Your feedback on the Northwestern path upgrade proposal

We are proposing to improve the Northwestern Path by separating the shared path at the Eden Terrace/Kingsland section into a separate cycle path and footpath. We consulted on this proposal from 27 September to 31 October 2019 and received submissions from 396 people.

Auckland Transport propose to separate the shared path at the Eden Terrace/Kingsland section into a separate cycle path and footpath. This upgrade will occur over an 850 metre stretch of the path between Central Road and Haslett Street.

Attachment 2: Feedback form

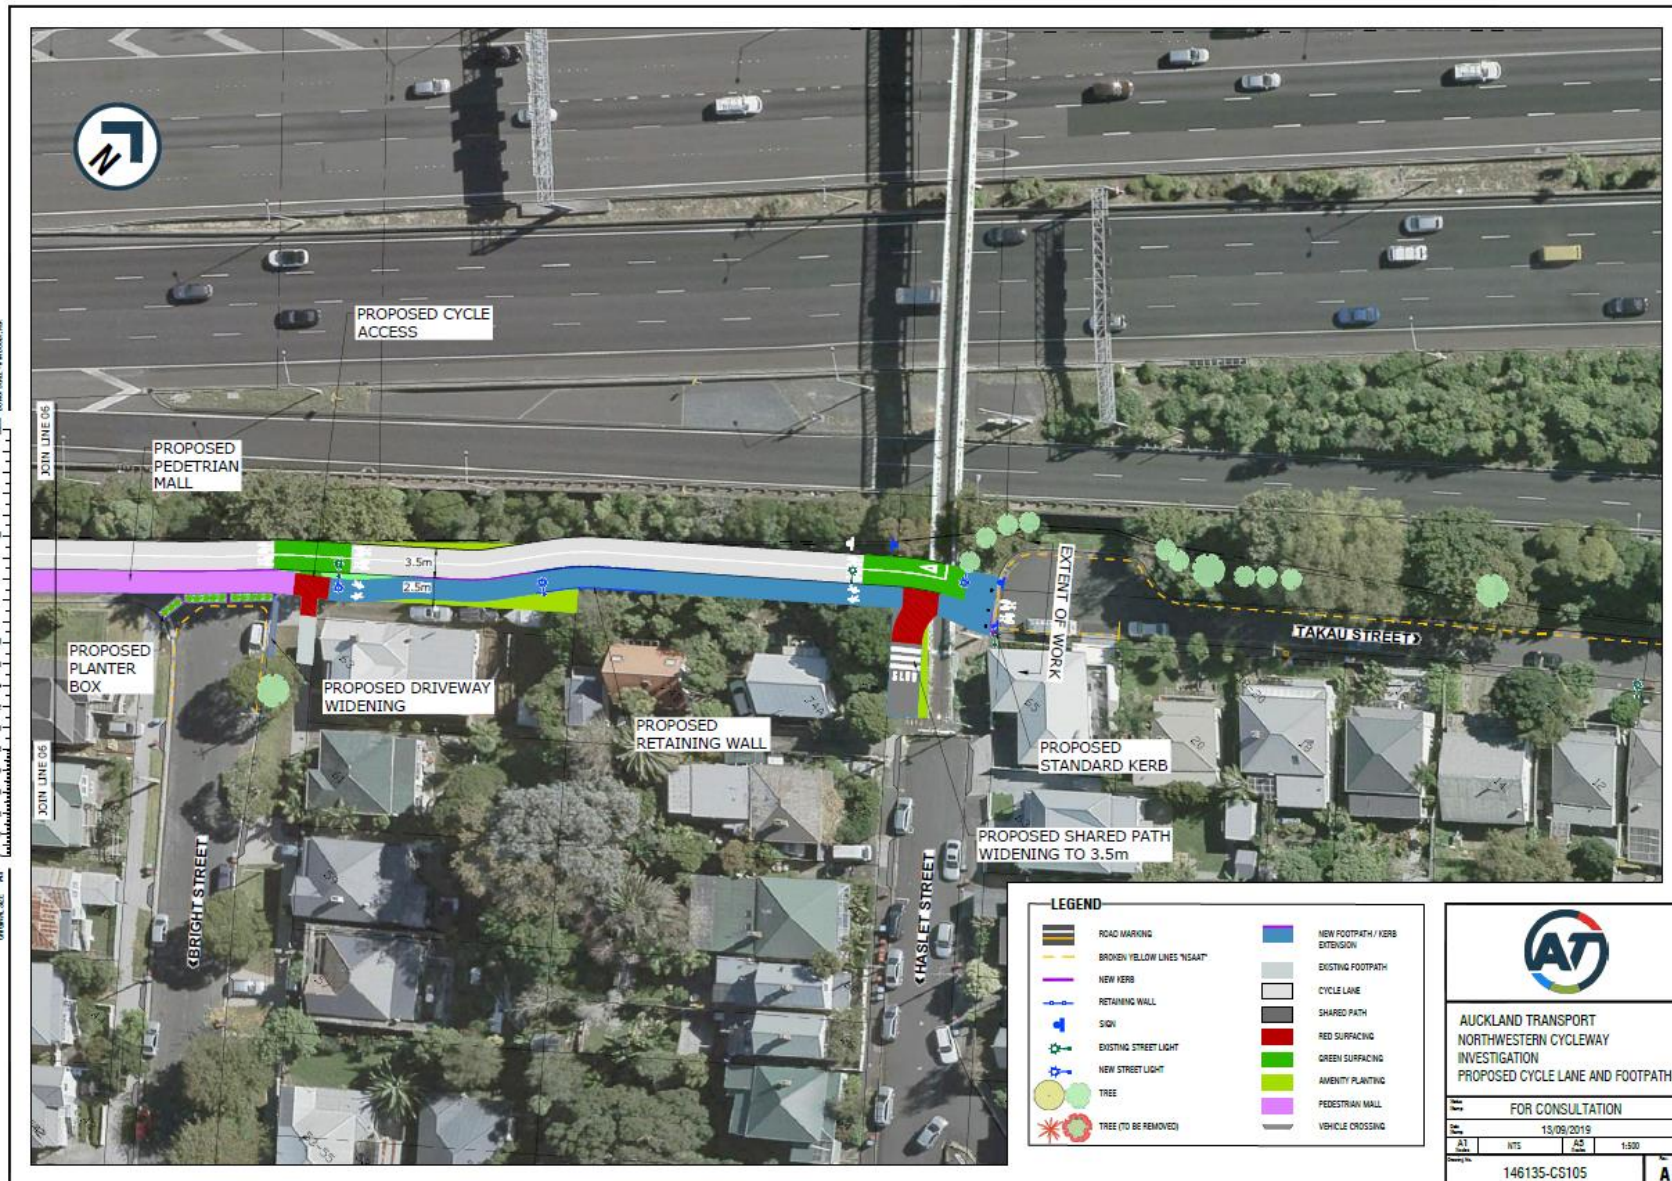
“Please review removing the small second reverse curve in the bike path between King Street and Hesketh Street (created by the proposed eastern streetlight placement).”

“Is it possible to make the interface at the western end safer? For example, it looks like the eastbound cycle lane could be moved further to the north, to create more distance between them and pedestrians.”

- please review removing the small second reverse curve in the bike path between King Street and Hesketh Street (created by the proposed eastern streetlight placement). Consider side street lights or similar here to avoid an even more "wiggly" cross-section through this part.

- similarly, consider whether the small reverse curve just east of Hesketh Street can also be straightened out. Finally, while we understand the financial / business case process reasons for leaving the Takau Street section out of this project, we would like to see works to improve the path through this section too (one of the two last on-street sections left on the Northwestern Cycleway).

Design suggestion in feedback	AT response
<ul style="list-style-type: none"> • The curvy section of the proposed cycleway opposite to King Street should be straightened to improve visibility and safety • The path should be wider to accommodate increased use in the future • The path should be wider to allow faster cyclists to safely overtake slower cyclists and pedestrians • AT's priority should be trying to make the full length of path as wide as it can be. Not just limited sections of it. • The bike path should be wider than the pedestrian path as pedestrians aren't going to crash into each other • If the pedestrian path is not straight and logical pedestrians might not use it 	<ul style="list-style-type: none"> - Where possible we are designing the path to be straight, however in some cases there are restraints that the paths will have to curve around. - The paths make the most of the width at the sections that have the least width available for the paths. Making the paths wider would create inconsistent widths along the paths. - The cycle path will be wide enough to allow faster cyclists to safely pass slower cyclists. - This section of the Northwestern Path is the second busiest cycleway in Auckland and there are conflicts regularly occurring between cyclists and pedestrians. The proposed improvements will help alleviate this issue and allow for further growth in active modes along this section of the Northwestern Path. - The footpath still needs to cater for large groups of users at the same time such as school children, walking groups and mobility impaired users to safely pass each other without getting in each other's way.

Design suggestion in feedback	AT response
<ul style="list-style-type: none"> At the eastern interface, it looks like the cycle signs aren't in the right place on the road (they should be offset to the north). With the vertical alignment here, it may not be possible for westbound cyclists to see the green surfacing from further back along Takau Street 	
Who goes where?	
<p>It's unclear where children on bikes and scooters should go</p> <ul style="list-style-type: none"> The two lanes should be separated by speed rather than mode, as children riding bikes or scooters would be safest in the pedestrian lane and some fast pedestrians like runners might be more comfortable in the cycle lane The paths should be separated by speed rather than mode, so someone on a wheeled device (scooter, bike, etc) can go in the pedestrian area as long as they stay strictly at walking pace and give way to pedestrians. That may be safer and kinder to small children learning to ride to school than to insist they (and their adult caregivers) ride with full-speed adult commuters. 	<ul style="list-style-type: none"> As per NZTA guidelines, children using scooters and bikes with a wheel diameter less than 355 millimetres are allowed to ride on the footpath. It would be difficult to enforce the give way and speed restrictions on a footpath and would not be a suitable environment to ride a larger bike. There is currently no bylaw allowing cyclists on a footpath with a restriction to speed.

Lighting	
<p>Streetlights should be moved further from the path</p> <ul style="list-style-type: none"> The plan shows several existing streetlights in the middle of the cycleway, or too close to the edge of the cycleway. These should be moved to a more suitable location. 	<ul style="list-style-type: none"> The streetlight locations will be reviewed as part of detailed design.

Design suggestion in feedback	AT response
<ul style="list-style-type: none"> 42 small native trees are proposed to be removed between King Street and Richbourne Street. These trees were recently planted and are an excellent mix of species so ideally those close to the boundary should be retained 	
<p>AT should not remove any of the any screen planting between the path and the motorway</p>	<p>Species and extent of plants installed or removed will be decided upon in detailed design and these points will be taken into account.</p>
<p>Invasive exotic species, especially Tree Privet should be removed</p> <ul style="list-style-type: none"> The invasion by tree privet is extensive on the NZTA side of the fence opposite the planned upgrade. It is replacing the native planting and starting to interfere with the form of the mature oaks there. It will continue to spread, and dominate further, if it is not controlled. Auckland Council has recently adopted an Urban Ngahere (Forest) Strategy which seeks to increase tree cover in the city from 18% to 30%. As a CCO, Auckland Transport has a responsibility to make up for the removal of existing trees by planting new ones nearby and protecting those that currently exist from invasion by weed species. 	<ul style="list-style-type: none"> This feedback will be passed onto NZTA for consideration Species and extent of plants installed or removed will be decided upon in detailed design and these points will be taken into account.

The layout of the path should be altered <ul style="list-style-type: none"> • At the Takau Street junction, the slope under the Haslett Street bridge should be levelled out to eliminate the current blind rise 	- We are looking into design options to maximise visibility and reduce speeds where Takau Street meets the Northwestern Path.
